**MACEDONIA PLANNING COMMISSION
MEETING AGENDA
APRIL 21, 2025**

Re: Plan Review Comments: 9764 Valley View Road lot consolidation plat

SUBJECT: Final Plan Approval - Specialty Lubricants Building Addition & Site Improvements

C101
Project No. 2024-317

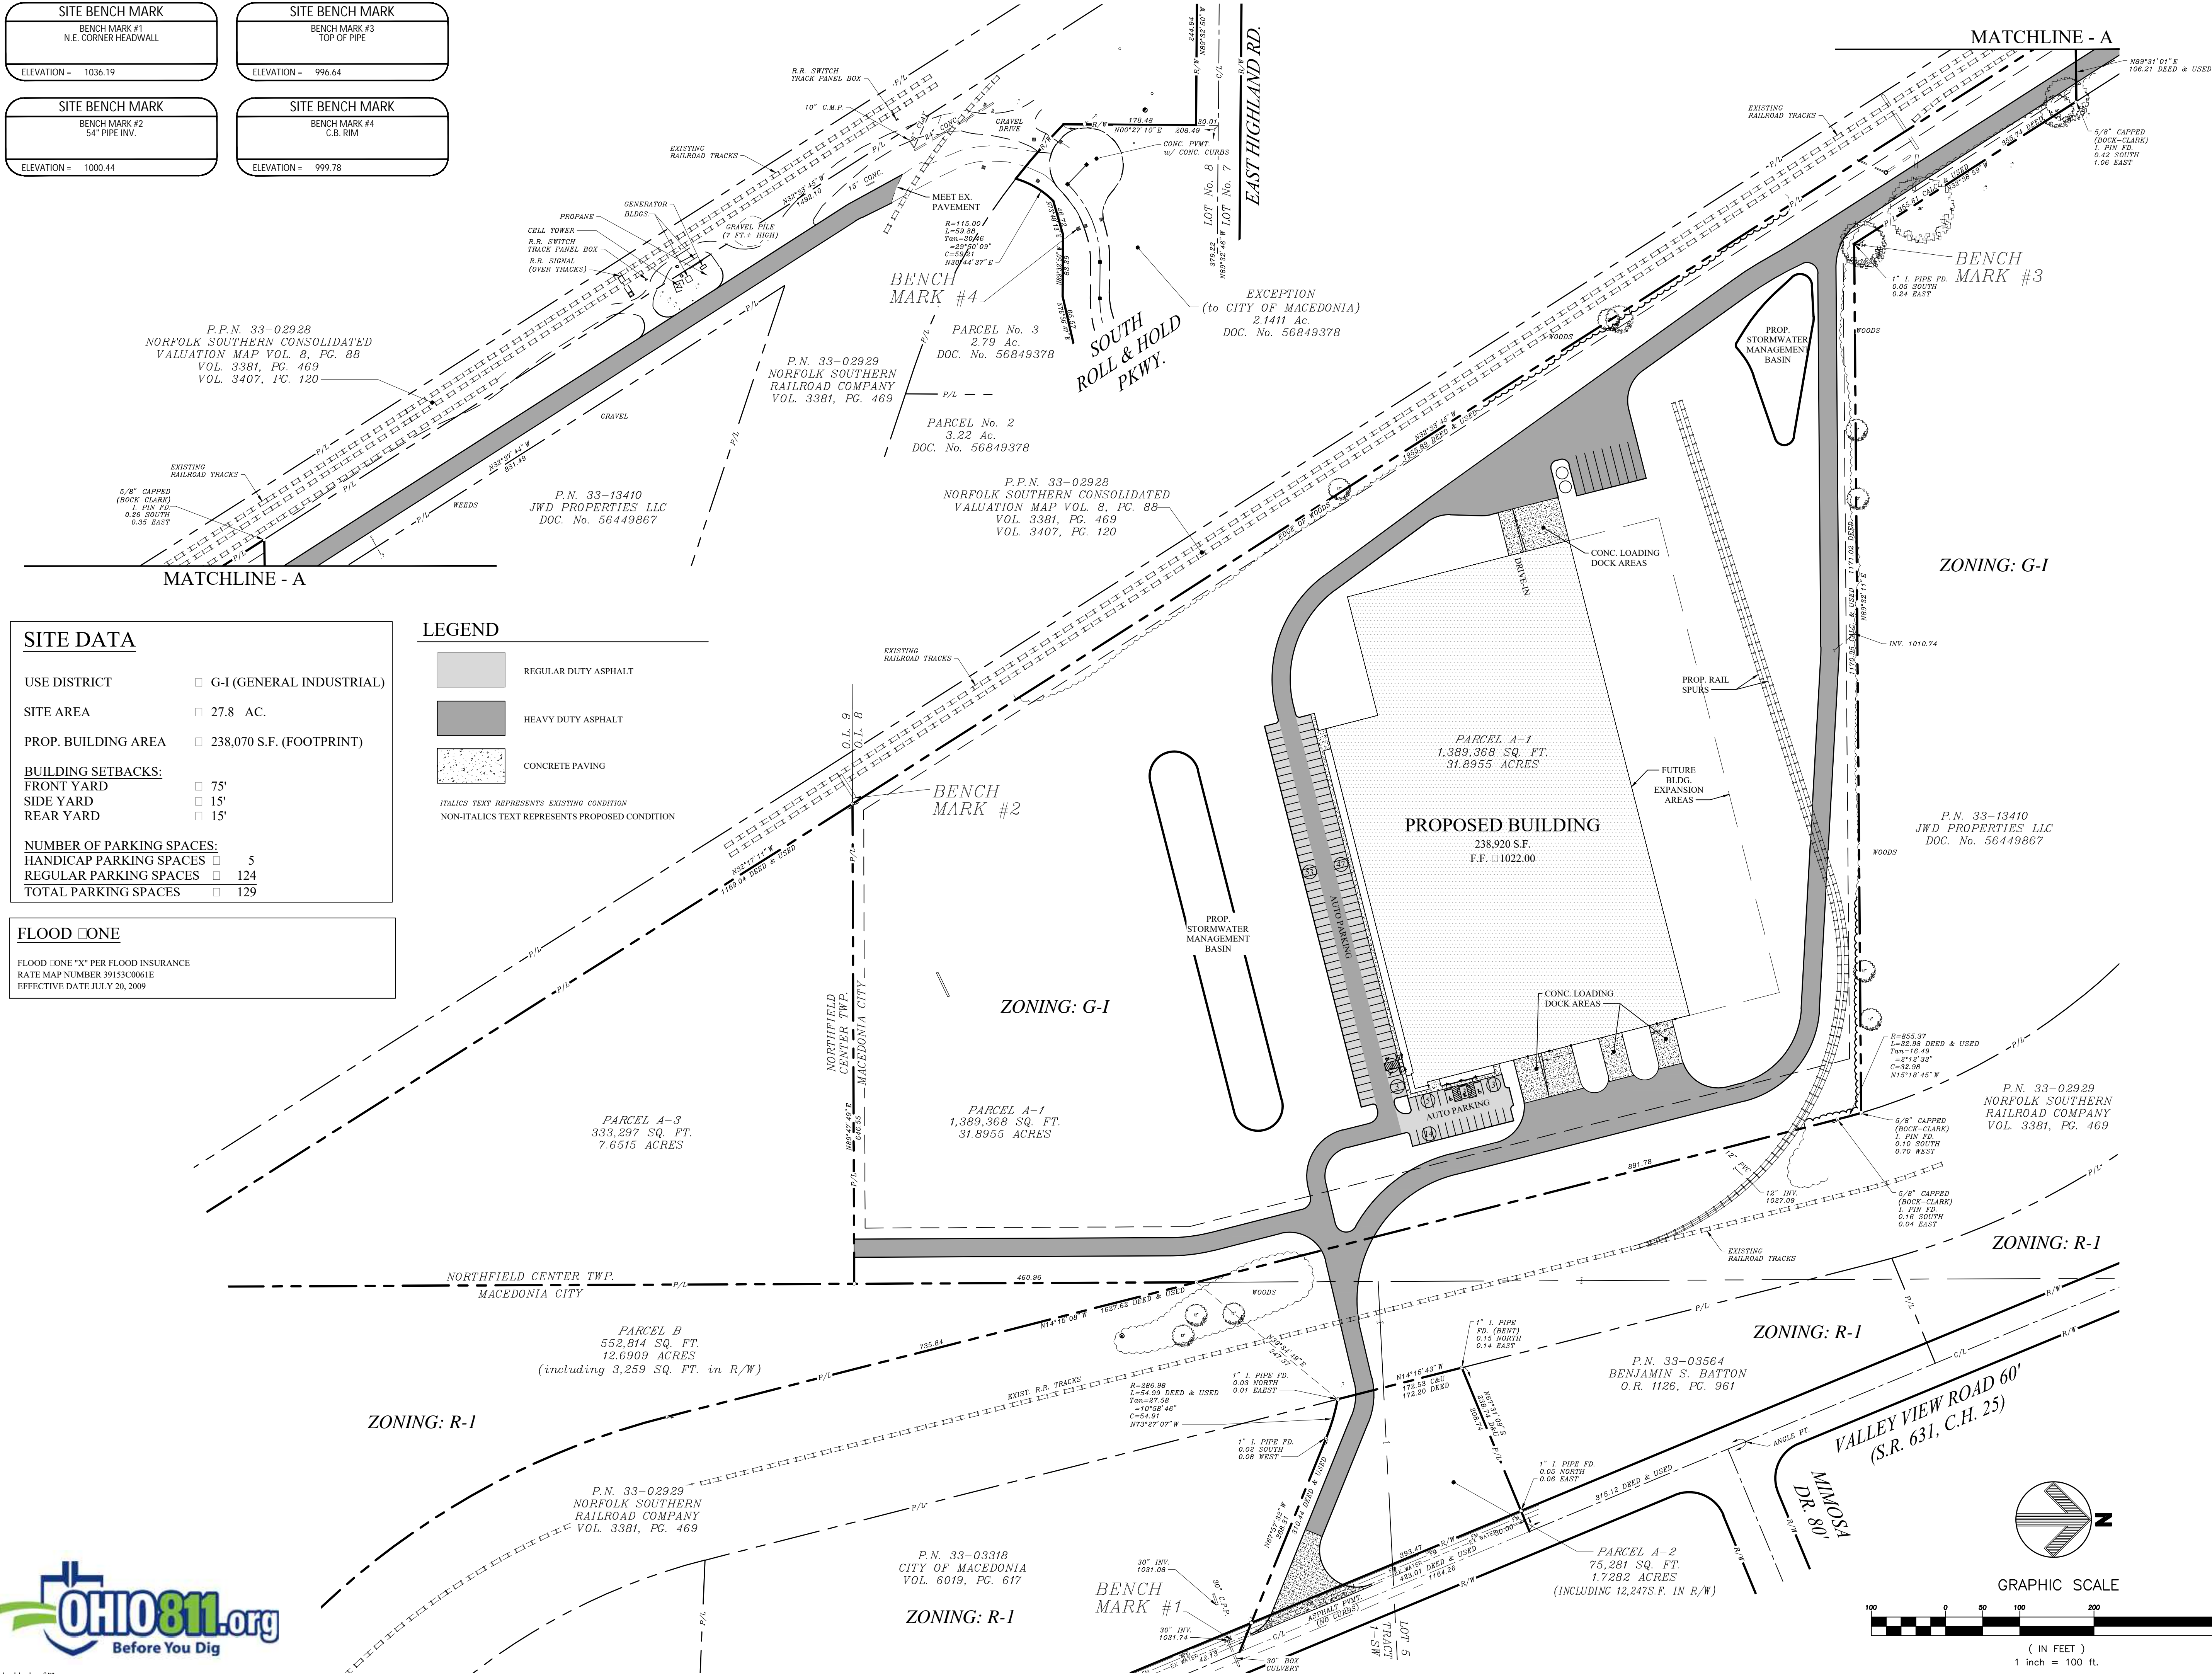
- d) The total required off-street parking based on the above break-down is 467. This means the site is deficient by 338 parking spaces if 129 spaces are provided. Sheet PP.1 proposes 387 land-banked parking spaces. However, the Planning Commission doesn't have the ability to waive the parking standard and permit land-banking.
ACTION ITEM: A variance from the Board of Zoning Appeals (BZA) is needed for the reduction and the minor discrepancy between Sheet PP.1 and C102 must be corrected.
